ADDENDUM NUMBER ONE (1)

Project: "The Commons" Buildings
Hinds Community College – Rankin Campus
Pearl, MS
HCC Bid #3307
PN: 24053

FROM: Dean Architecture, P.A.
661 Sunnybrook Road, Suite 140
Ridgeland, MS 39157
(601) 939-7717

Sheet Number: A101b
GYMNASIUM FLOOR PLAN - PART "B"

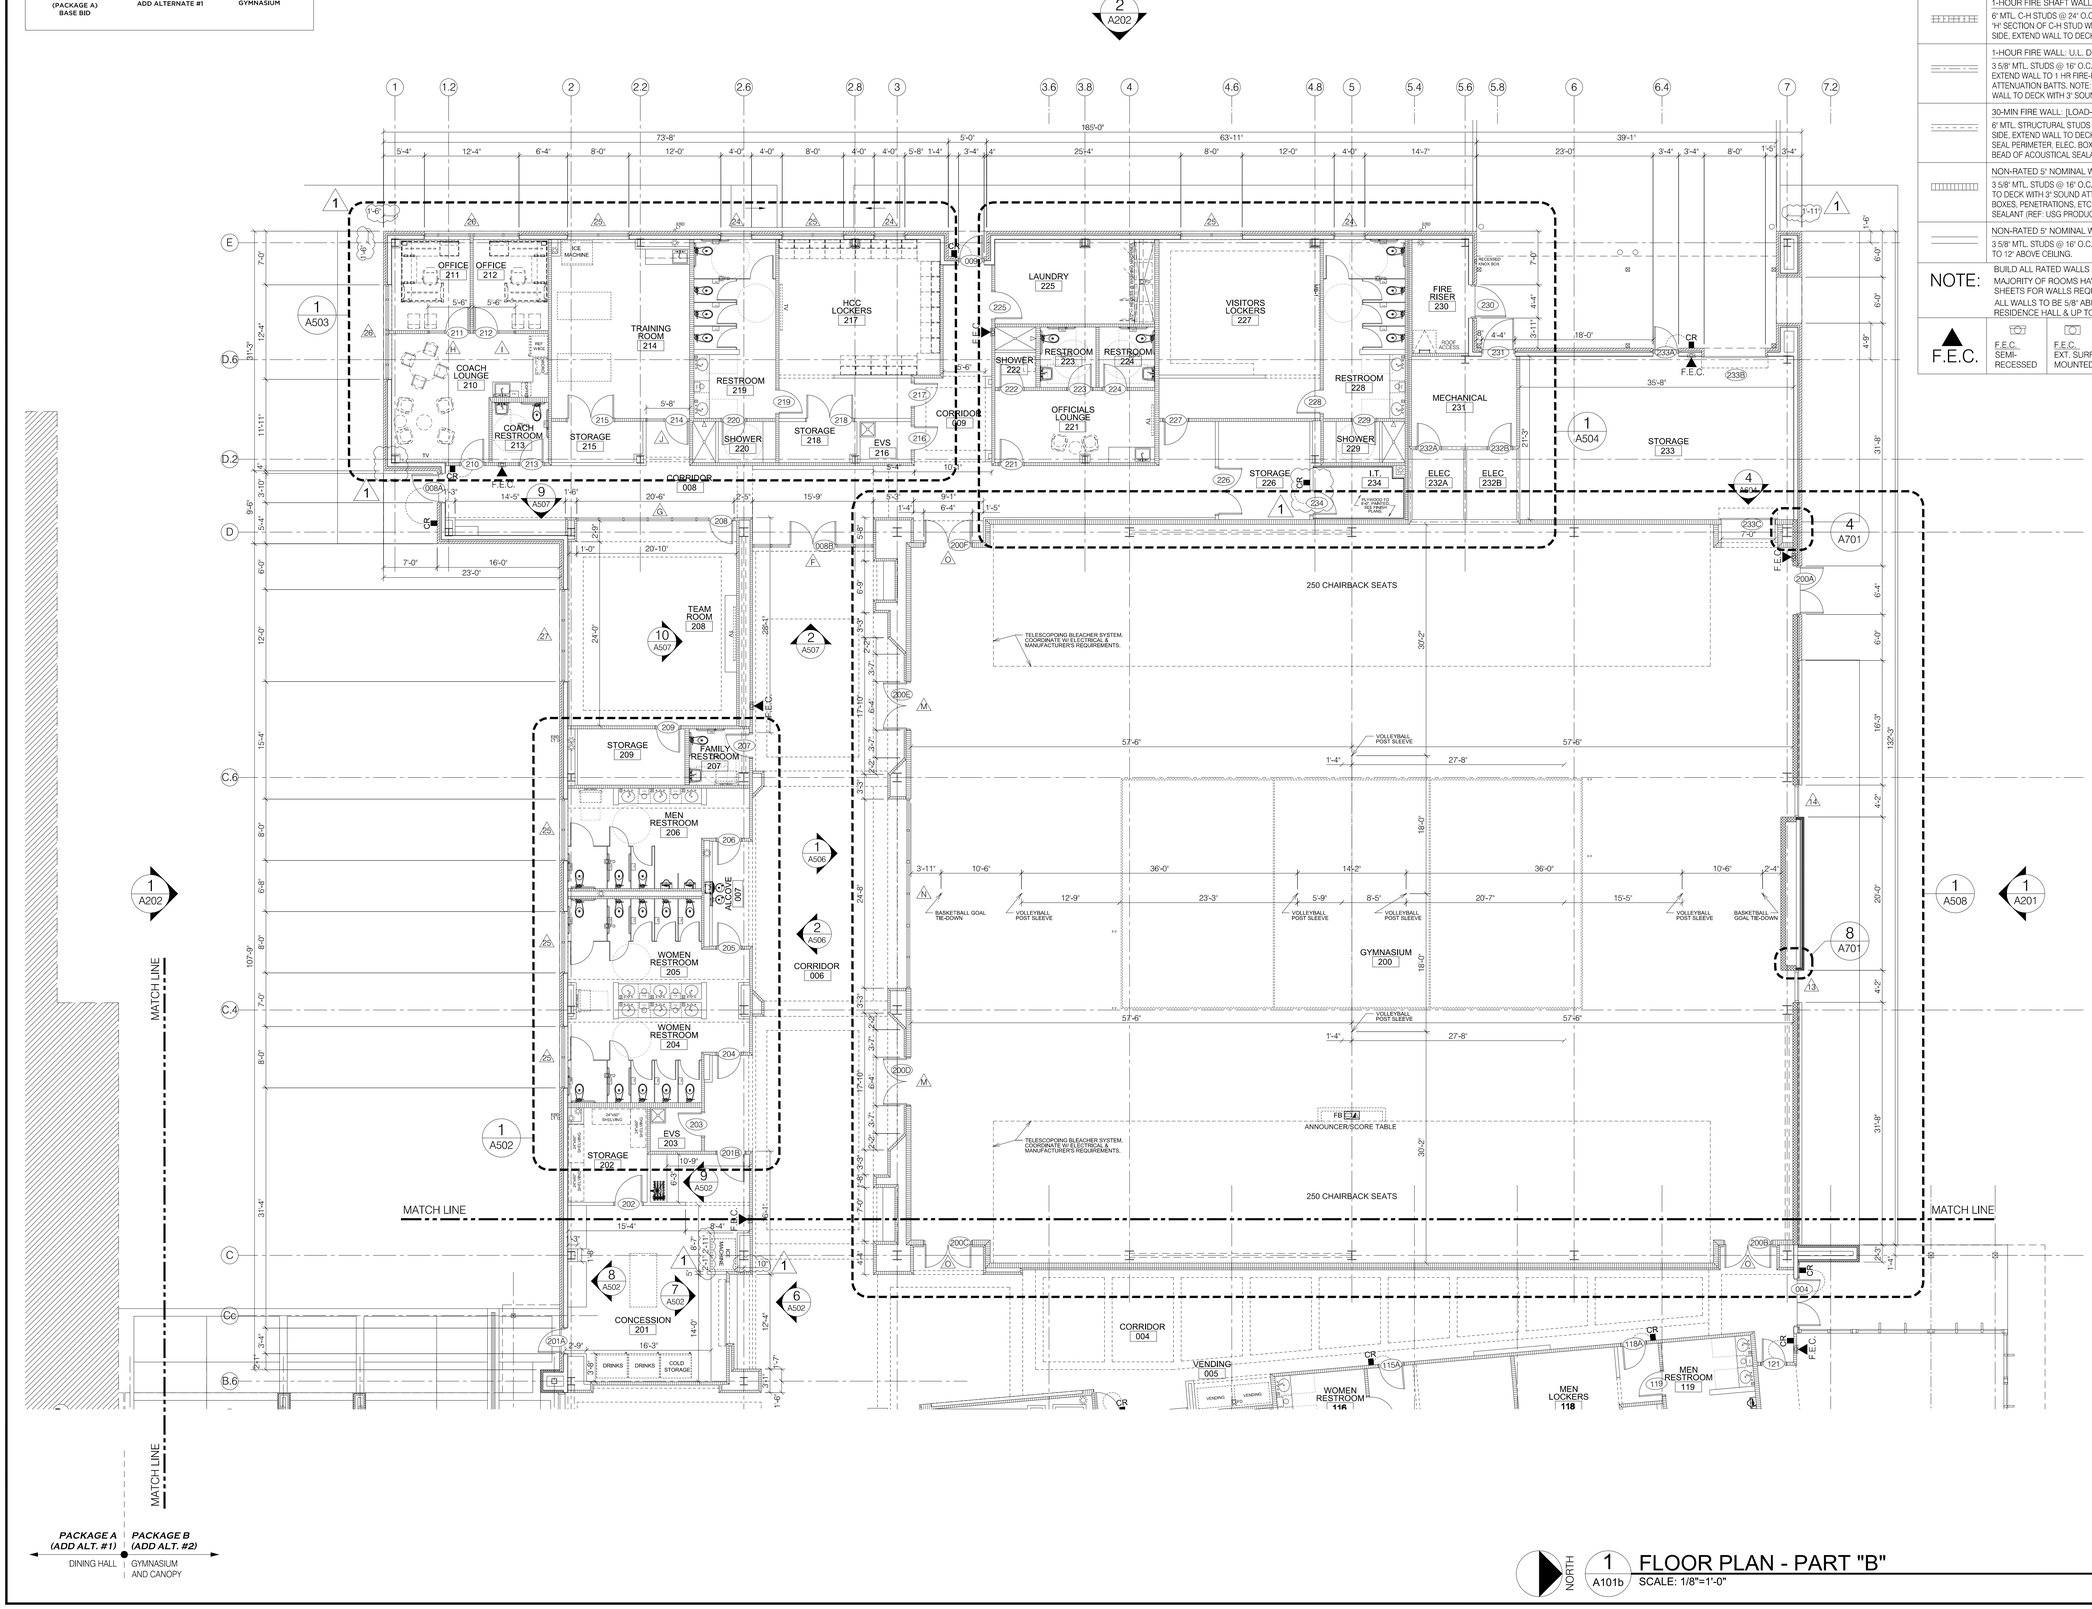
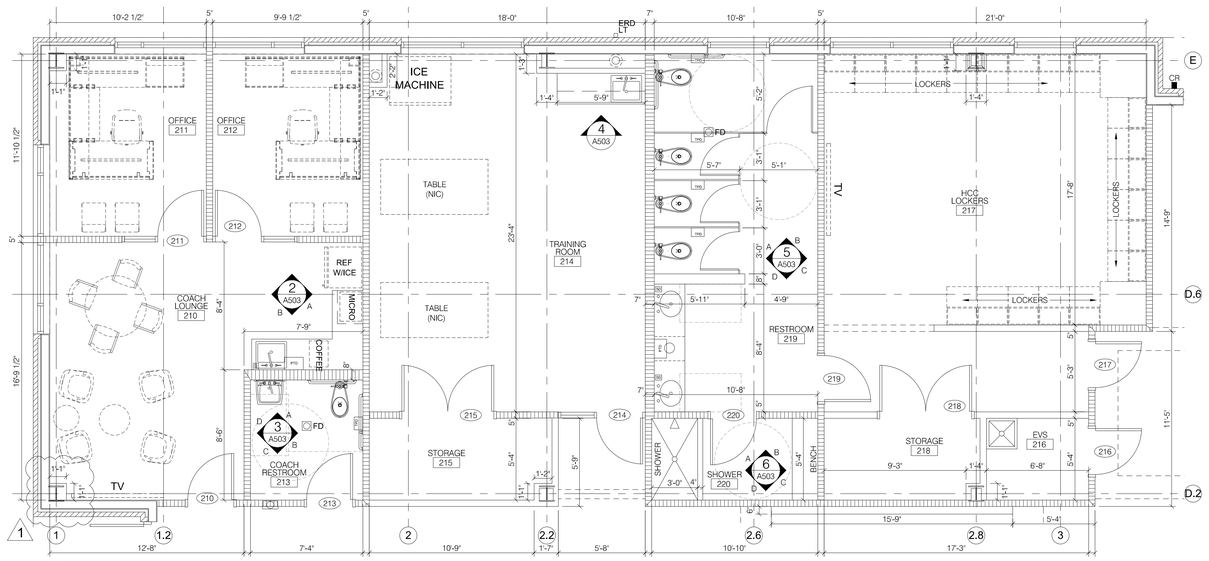
ITEM #2: SHEET A101b - GYMNASIUM FLOOR PLAN PART B.
Door 234 to I.T. Room 234 – Add Card Reader to this door and provide electrical rough in per detail 3/E421 on Electrical Drawings – Dimension Clarifications on Plan.

GYMNASIUM ENLARGED FLOOR PLAN & INTERIOR ELEVATIONS

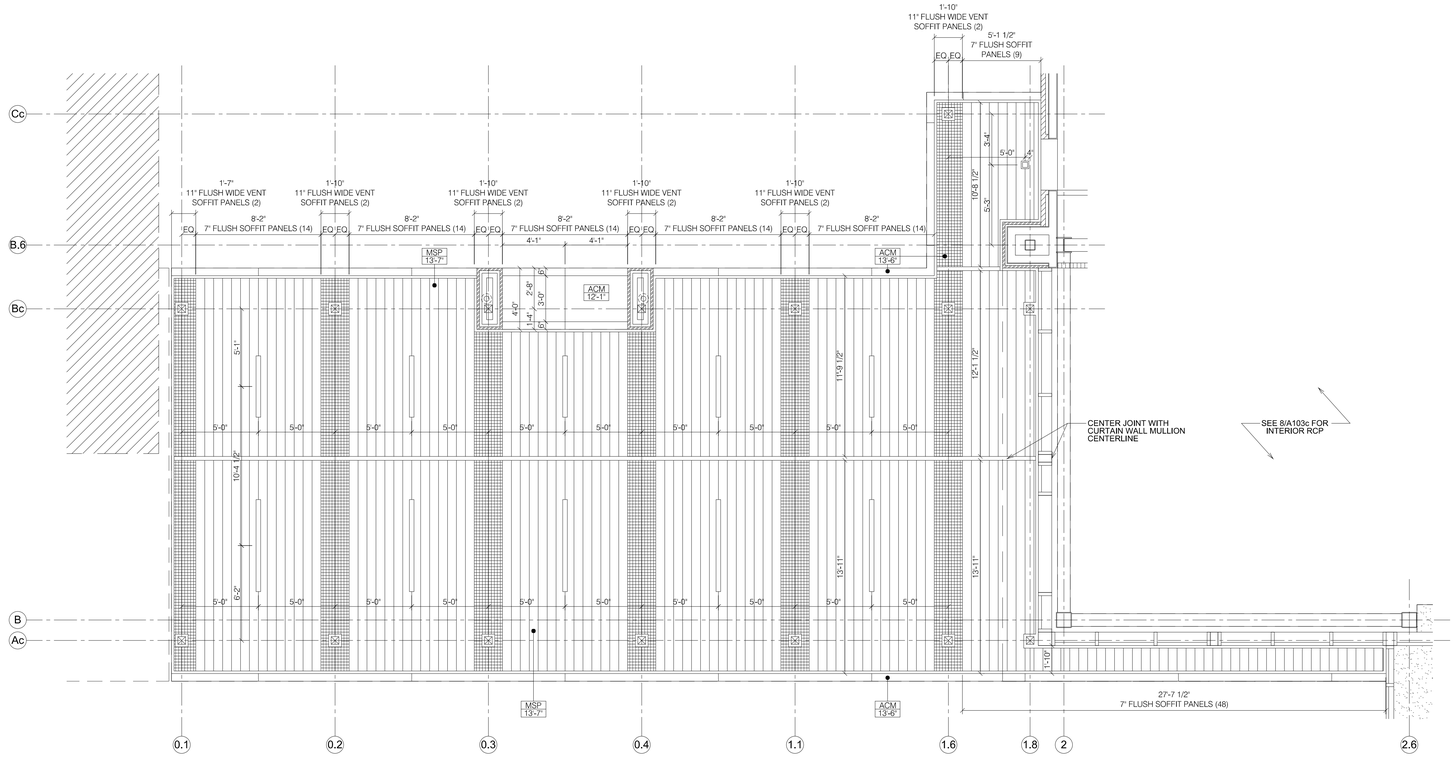
ITEM #3: SHEET A503 – GYM ENLARGED PLAN AND INTERIOR ELEVATIONS
Remove existing sheet and replace with revised sheet dated 9/30/2025 – Added column wrap at coaches' lounge, Room 210.

Sheet Number: 1
A509
GYMNASIUM ENLARGED FLOOR PLAN & RCP

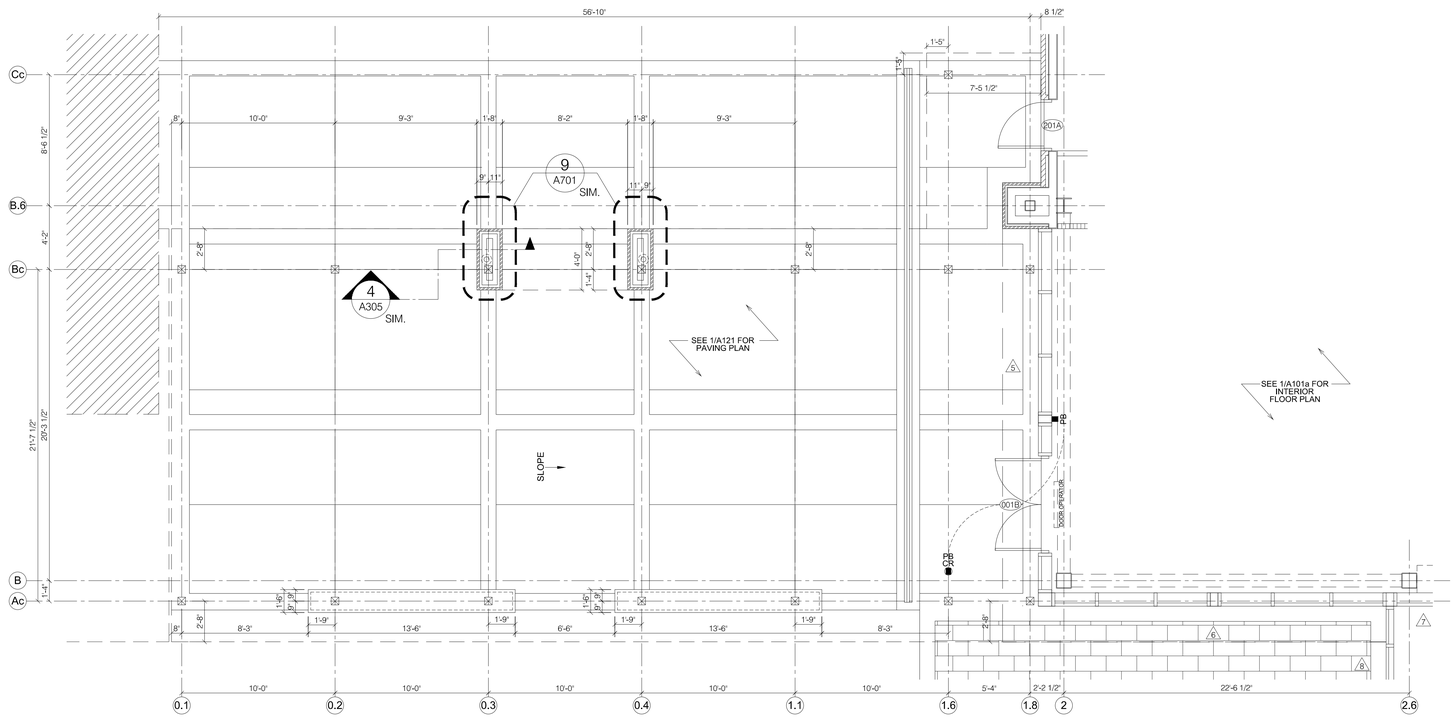
ITEM #4: SHEET A509 - GYMNASIUM ENLARGED FLOOR PLAN AND RCP.
Remove the existing sheet and replace it with the revised sheet dated 9/30/2025.
Added notes and dimensions.

C301

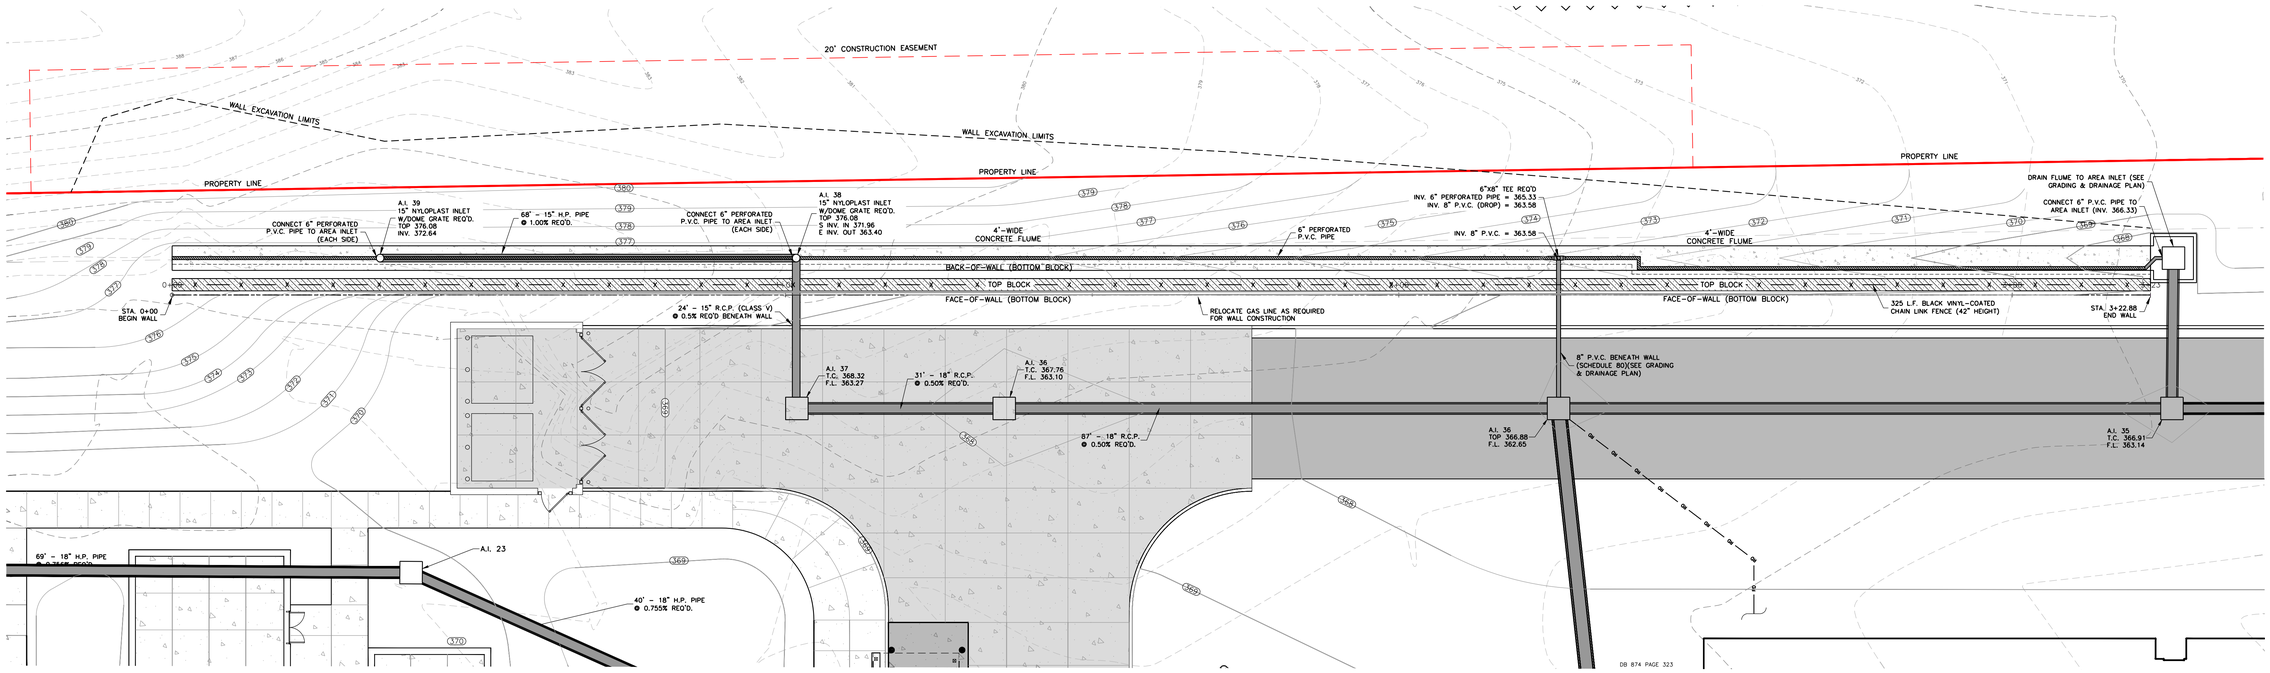
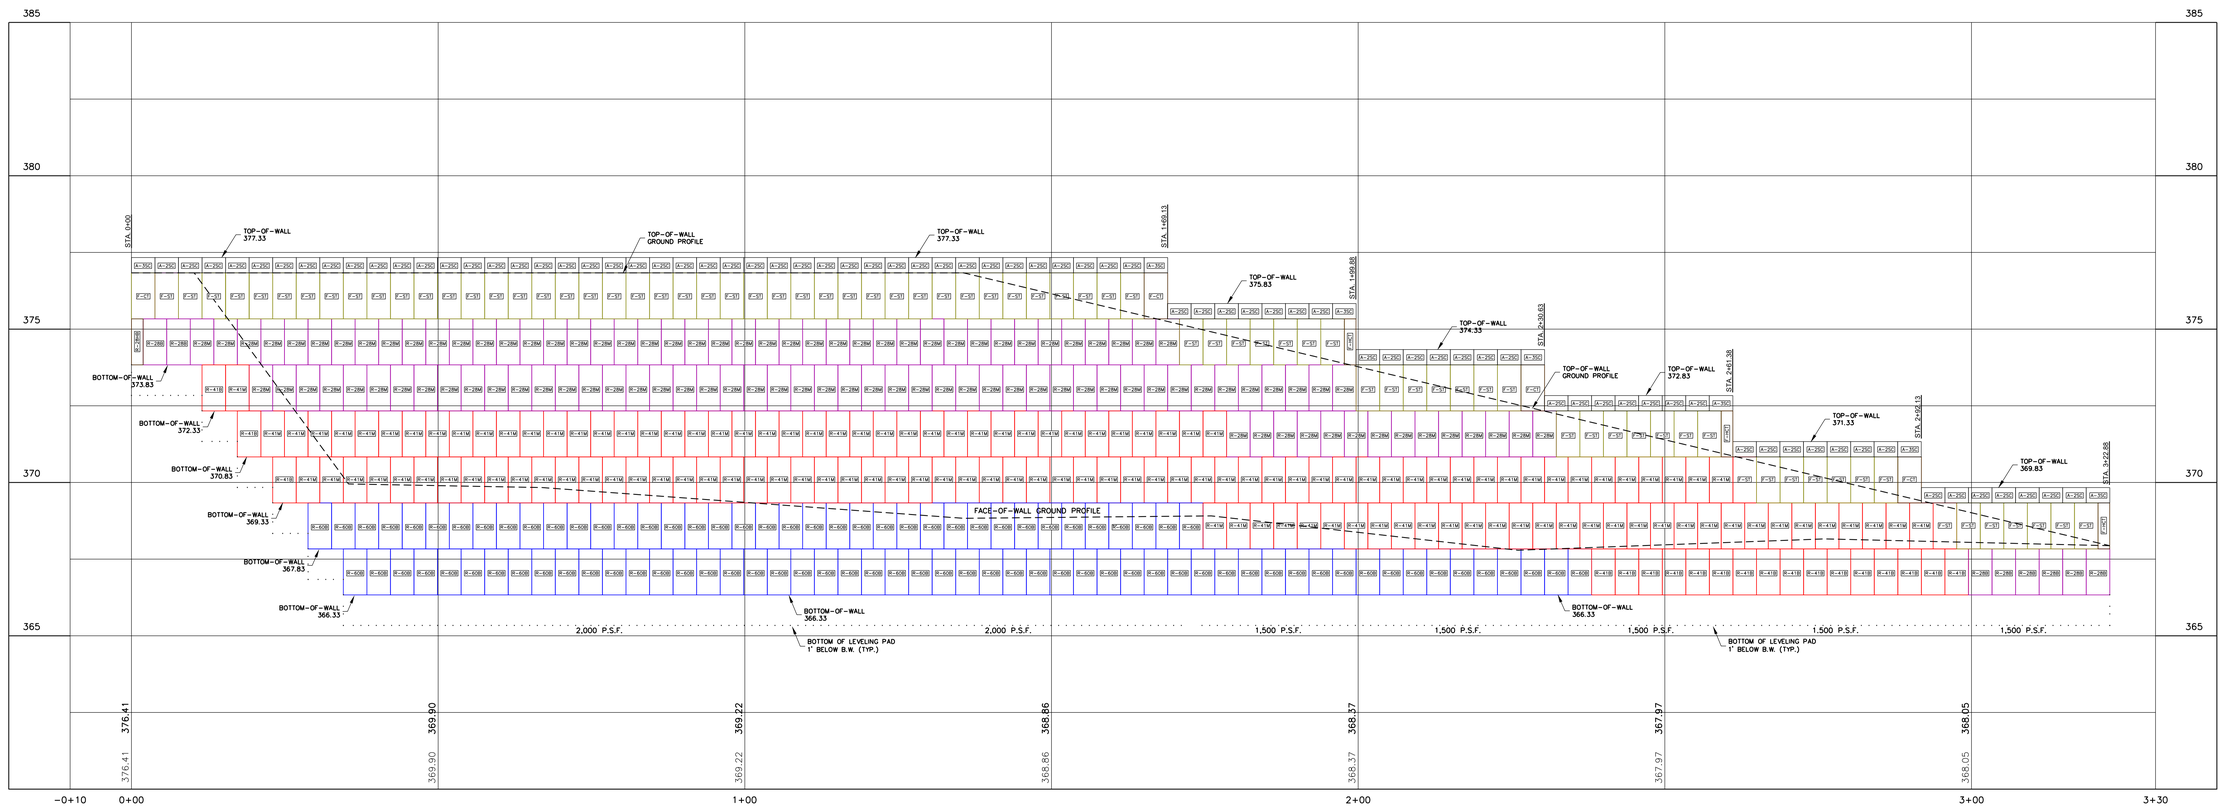
1.8 Item #5 – Sheet C301 Package A – PVC Sleeve locations were added to the plan sheet, the location of the new gas service for the Gym was revised, and various notes on sheet were revised.
